RESOLUTION OF THE TOWN OF ST. LEO TOWN COMMISSION APPROVING SAINT LEO UNIVERSITY INC. INTRAMURAL FIELD LANDSCAPE BUFFER PLAN AND LIGHTING PLAN.

MEMORANDUM

RE: Saint Leo University Intramural Field Landscape and Lighting Plans

Site Lighting Layout

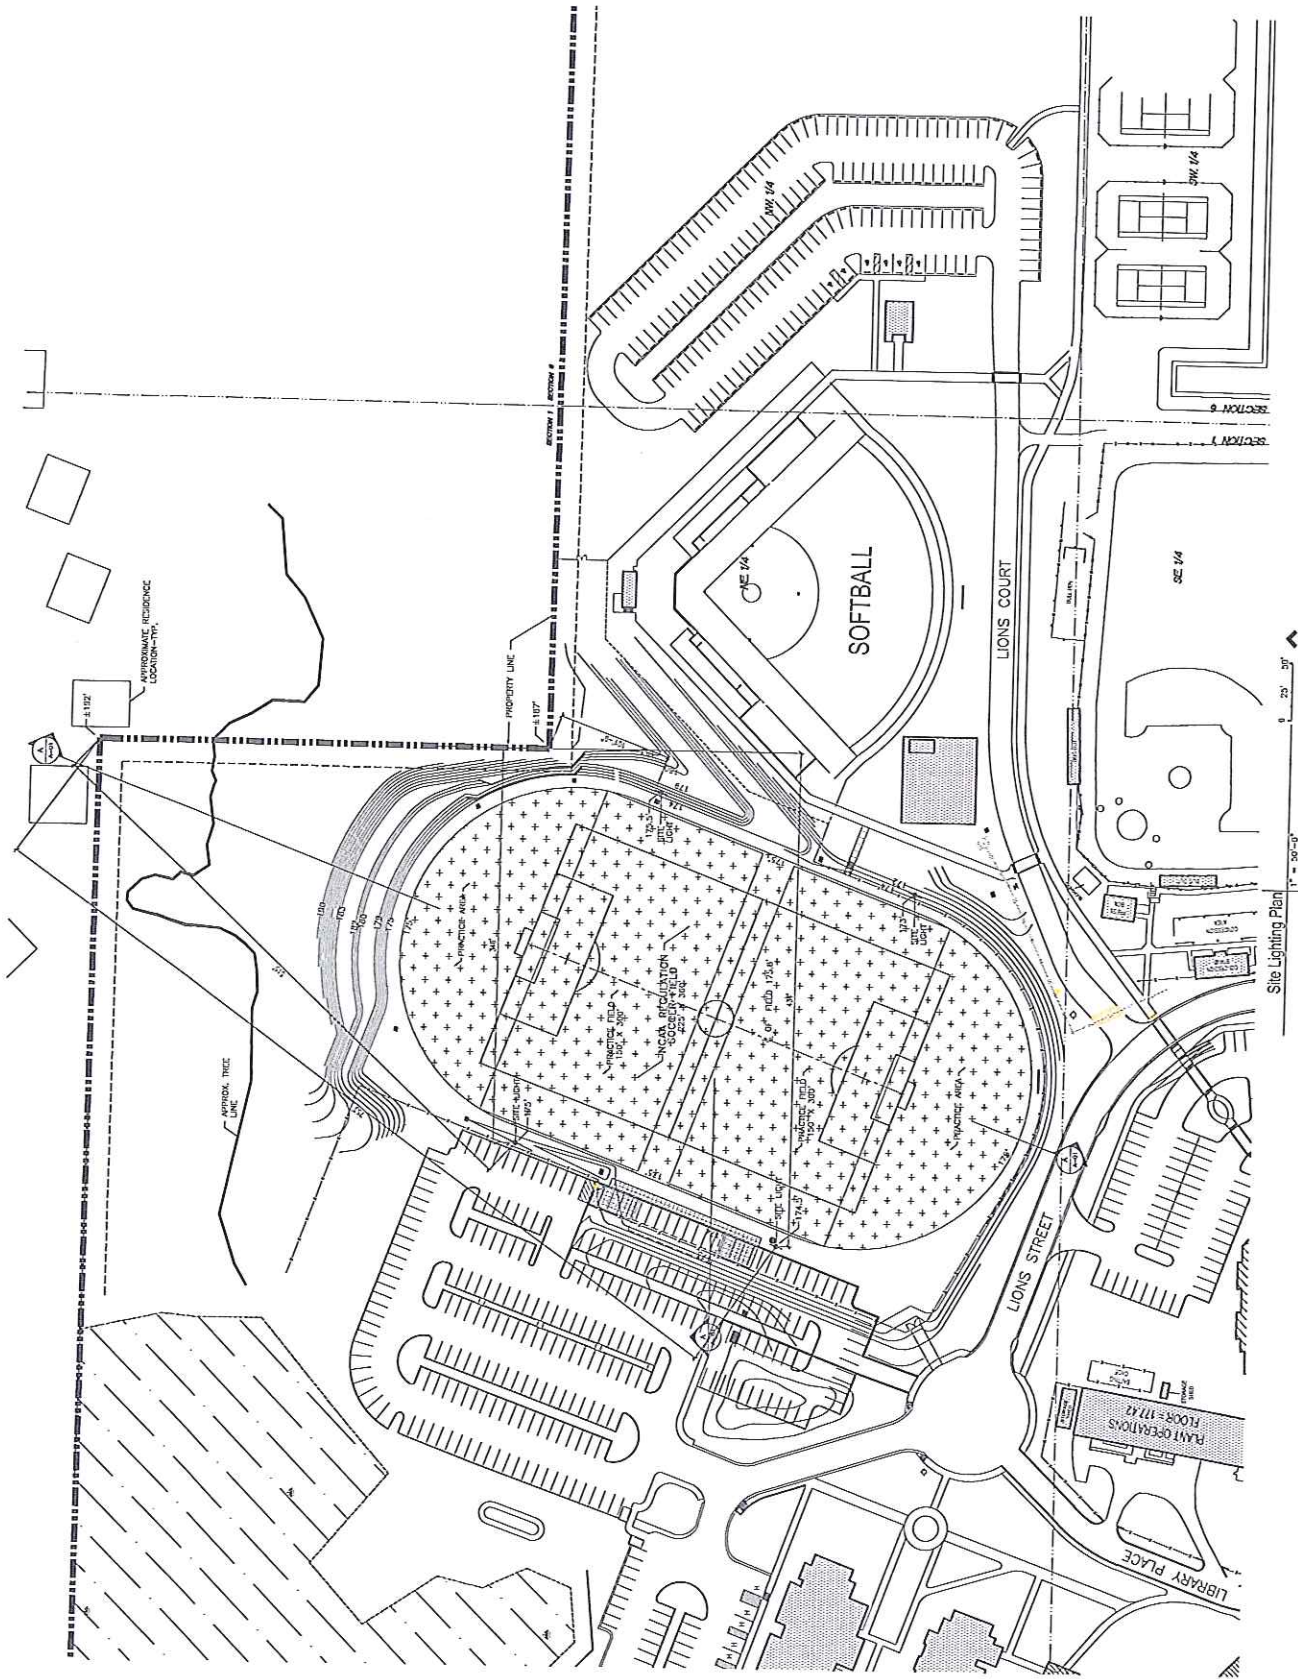
The lighting fixture is designed to reflect light downward. Appendix B provides the University's narrative, a diagram of the light fixture, photographic examples of actual sports field lighting utilizing this light fixture, a drawing depicting the light pole locations (S1-S4) and spread of illumination from the light fixtures on the field (Drawing A) and a drawing depicting the illumination spillage around the perimeter of the field (Drawing B). As shown by the photometric (illumination) drawings and example photographs, the outward illumination created by the lights would be confined to a small area beyond the Intramural Field. It is noted that these lights are the same lights utilized for the Softball Field. As of this date, no complaints have been filed with the Town regarding the Softball Field lights.

The distance of the closest lights (S2 and S3) relative to the adjacent Lake Jovita residences to the north is approximately 515 feet and 480 feet respectively. These lights are generally oriented perpendicular to these residences. The distance of the closest light (S1) oriented toward the Lake Jovita residences to the east is approximately 1,580 feet. The University has provided cross sections to illustrate the relationship of the light orientation, distance and elevation relationships to the adjacent Lake Jovita residences to the north (cross section A/A-01) and east (cross section B/A-01).

Based on the height of the lights, distance of the lights from adjacent residences, lighting orientation/spillage, elevation changes and intervening tree canopy, there appears to be no lighting impact on the adjacent residences to the north and east.

Spill

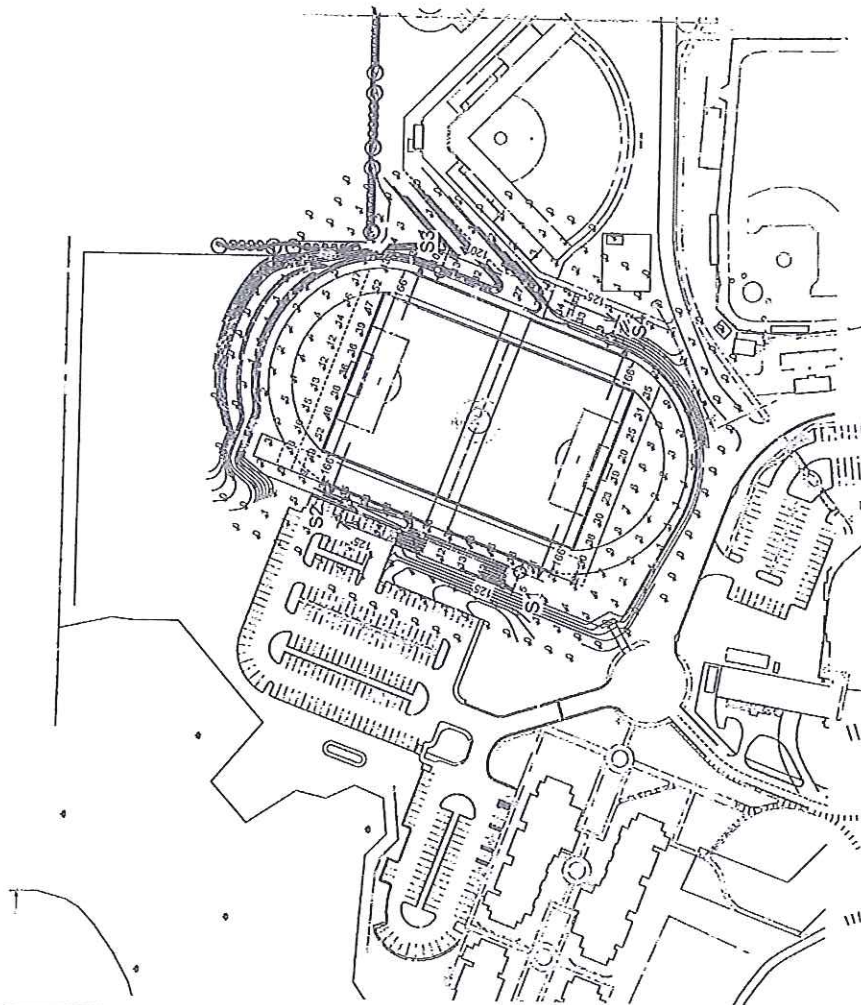
Towards the north, computerized foot candle calculations show 0 foot candles beyond approximately 200' from the north-most light poles, and towards the west, they show less than 1 foot candle beyond approximately 100' from the west-most light poles. While we have not received the calculations for the east side of the field, since the lighting design is symmetrical, we can comfortably say that it would match the west side, thus, towards the east, there will be less than 1 foot candle beyond 100' from the east-most light poles.

On the north, with the nearest residence approximately 500' from the closest light pole, it is clear that there will be no light spillage onto the northern residential properties. Towards the east, the closest residence is over 1,270 feet from the closest light pole for this project so it is clear that to the east also, there will be no light spillage onto the residential area. The photo of the Weston Regional Park, which utilizes the same type of light fixture, clearly shows the lack of light spillage of these lighting systems. The sports lighting will have no discernable impact on the adjacent residences either to the north or to the east.
